This Service Information bulletin supersedes SI B66 06 15 **dated September 2015.**

### **Sporadic Check Control Messages of the Driver Assistance System**

F32 (4 Series Coupe)

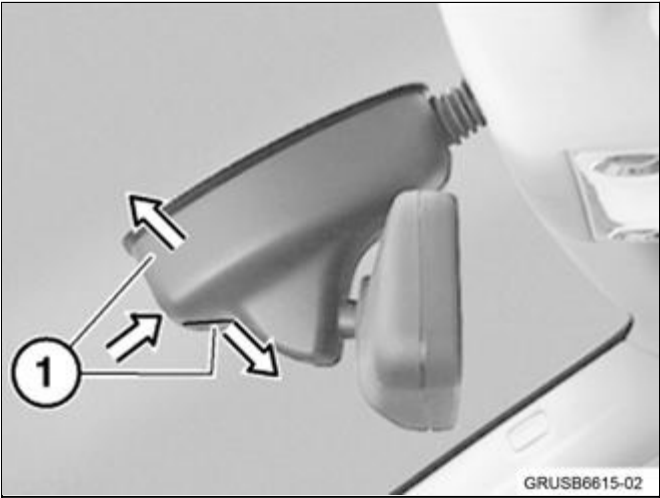
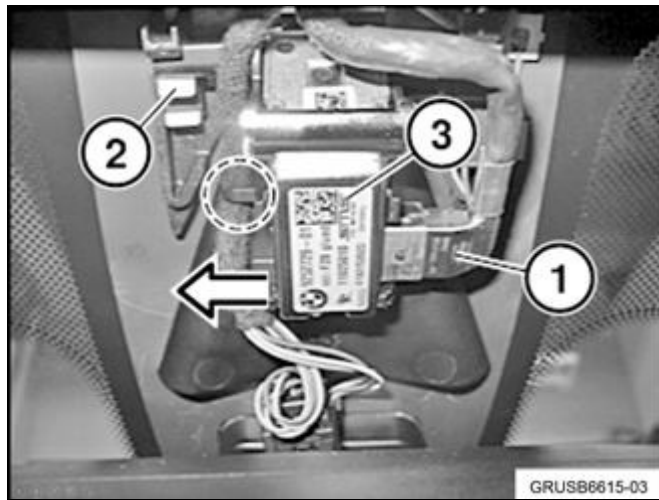
Incorrect calibration of the temperature sensor in the KAFAS camera.

Install a KAFAS camera with:

- A date code of 153214 and higher
- OR
- Identified by 3 white dots

- The affected units will have a date code of 152701 to 153213.
- The date code is highlighted by the green arrow and box.
- The updated part will have a date code of 153214 or higher

- **NEW** Note: Some updated parts may not have a date code of 153214 or higher. Rather, they will have 3 white dots, as shown.

3. **NEW** Replace the KAFAS camera if the date code range from 152701 to 153213.
4. Refer to Repair Instructions REP 66 51 030 – remove and install/replace KAFAS camera
